Prairie Island Nuclear Generating Plant Units 1 and 2
Dockets 50-282 and 50-306
License Nos. DPR-42 and DPR-60

Response to NRC Request for Additional Information Regarding Application for Renewed Operating Licenses

Enclosure 1
Response to Follow-up RAI B2.1.38

Figure 1 Weight Loss in Acid vs. Volume Fraction of Cement (based on data from Reference 7)

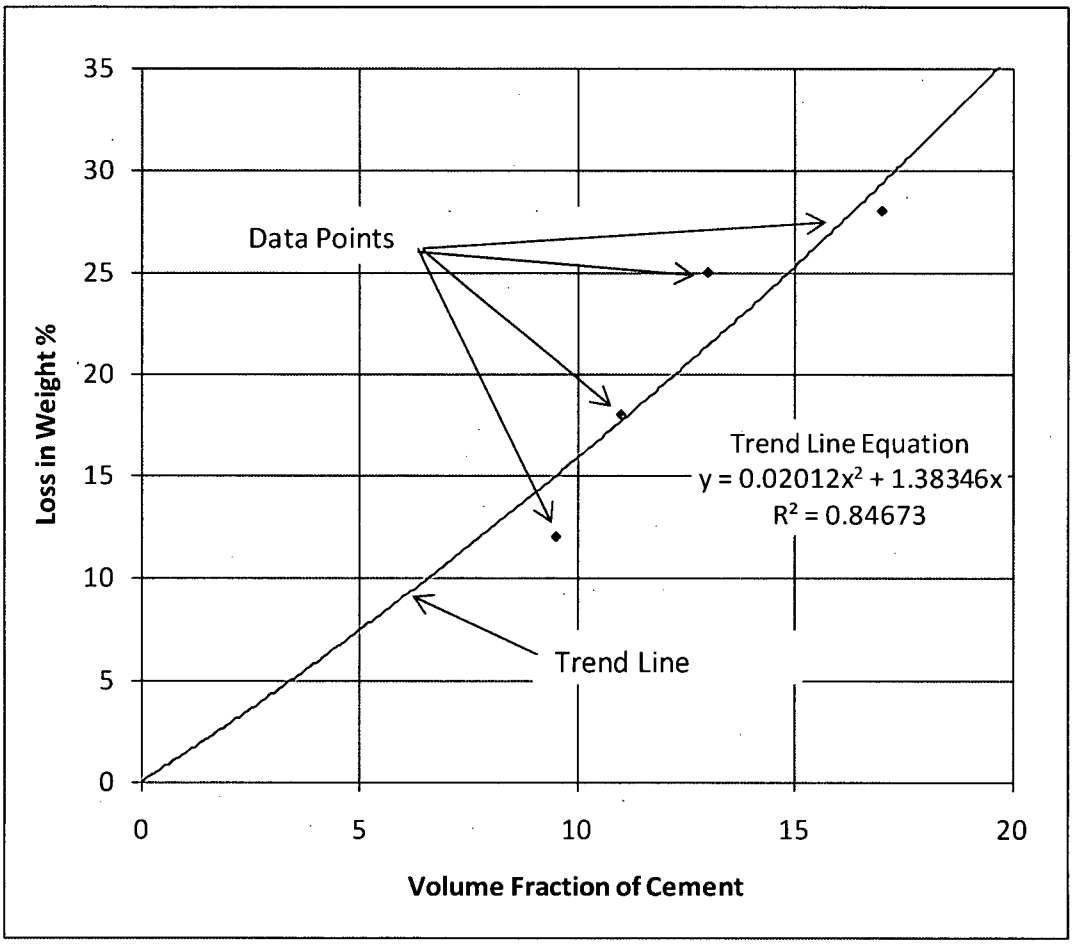
d) In Section 5.2.3 of Reference 1, the rate of degradation estimated for PINGP concrete is two times that used previously for Salem/Connecticut Yankee plants to account for the difference in the type of concrete aggregates at PINGP. Please advise if NSPM has performed or intends to perform any tests to confirm the use of this assumption for the degradation rate.

The acceleration factor of 2.0 for the increased rate of degradation resulting from the presence of about 5% carbonate-based aggregate at Prairie Island relative to the 0% carbonate-based aggregate at the cited plants was based on engineering judgment.

Tests of the effects of acids on reinforced concrete show that acids weaken concrete by dissolving cement and carbonate-based aggregate (Page 29 of Reference 4 and page 4

of Reference 6). Tests discussed in Reference 7 indicate that the weight loss experienced by cubes of concrete immersed in acid increases as the volume fraction of cement in the concrete increases. These tests were performed on concrete that had non-soluble aggregate (i.e., only siliceous aggregate and no calcium carbonate-based aggregate). This increased weight loss is attributed to the fact that, as the volume fraction of cement increases, the volume fraction of the concrete that is soluble in acids increases. Based on this result, it is reasonable to assume that the effect of boric acid on concrete containing soluble aggregates will follow a similar pattern; i.e., the degradation of concrete due to boric acid will increase as the total fraction of material in the concrete that is soluble in acids increases, whether that soluble material is cement or aggregate.

Quantitative data in Reference 7 for weight loss of concrete cubes when exposed to an acid concentration of 3% is shown in Figure 1. A trend line is shown on the figure that provides an equation for quantifying this dissolution behavior. As can be seen, the weight loss increases somewhat more strongly than linearly as the volume fraction of cement, (i.e., of soluble material), increases.

A footnote on page 10 of Reference 4 indicates that concrete normally contains 10 to 15% of cement, or an average of about 12.5%. As noted on page 2-2 of Reference 1, the amount of carbonaceous aggregate in the concrete used at Prairie Island was about 5%. Adding this 5% to the average 12.5% cement results in a total of 17.5% soluble material in the concrete at Prairie Island as compared to the 12.5% in a concrete with all igneous (no carbonate) based aggregate such as was used at the cited plants. (Section 8.1.3 of Reference 8) Using the trend line equation shown in Figure 1, increasing the fraction of soluble material (cement in the figure, cement plus soluble aggregate in this case) from 12.5% to 17.5% increases the weight loss by a factor of 1.49. This indicates that the assumed factor of 2.0 increase in severity of acid attack to account for the presence of 5% carbonate-based aggregate is conservative by a significant margin (2 vs. 1.49).

Based on this result, it is considered that there is no need for additional tests to evaluate the effects of the carbonate-based aggregate used at Prairie Island.

General Arrangement of Change Fixture Supports

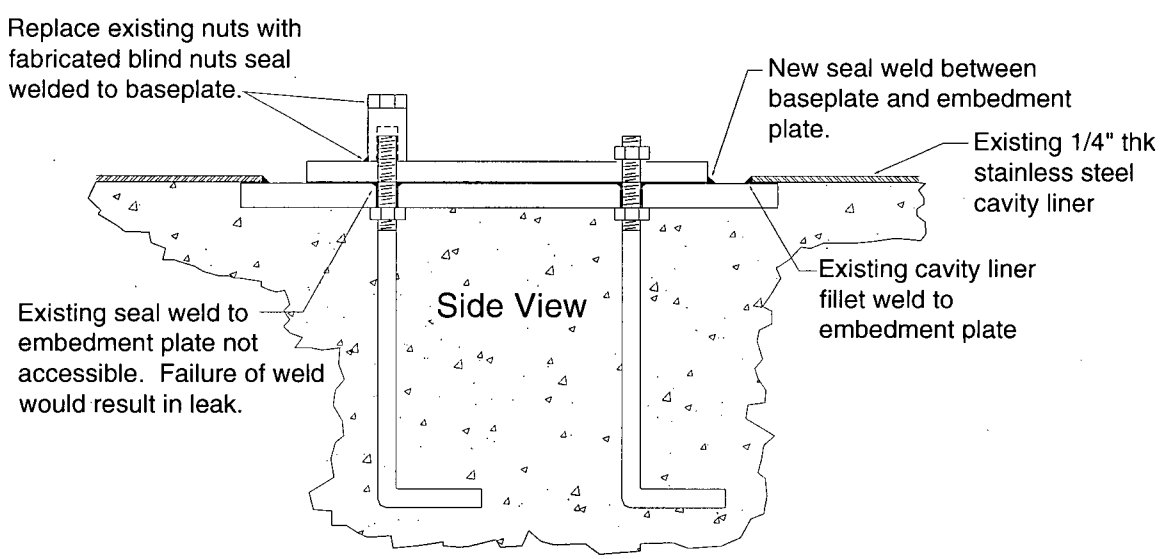
i) Page 52 of Reference 2 identified five recommendations to address reactor cavity leakage. Please provide NSPM's action plan and schedule for completing these five recommendations.

The plant management review of the Root Cause Evaluation considered the value, need and sufficiency of each recommendation. The current repair plan that emerged from these reviews is to replace the existing anchor nuts with new fabricated blind nuts that are seal welded to the existing baseplates. In addition, the existing baseplates will be seal welded to the embedment plates. The new welds will be readily accessible for examination to ensure the existing anchors and baseplates are leak tight. The following sketch depicts a typical RCC change fixture support showing the planned repairs. Similar repairs will be made to the internals stands supports.

This repair strategy effectively accomplishes the goals of recommended steps 1 through 3, the intent of which is to permanently repair refueling cavity leakage, but in a more focused and dose-effective manner. The guide tube supports which are mounted to the refueling cavity wall were concluded to be unlikely sources of leakage and will not be sealed in a similar manner. Although the guide tube supports are of similar construction, past success at mitigating leakage by sealing the supports of the internals stands and RCC change fixture suggests that leakage occurs only at those locations.
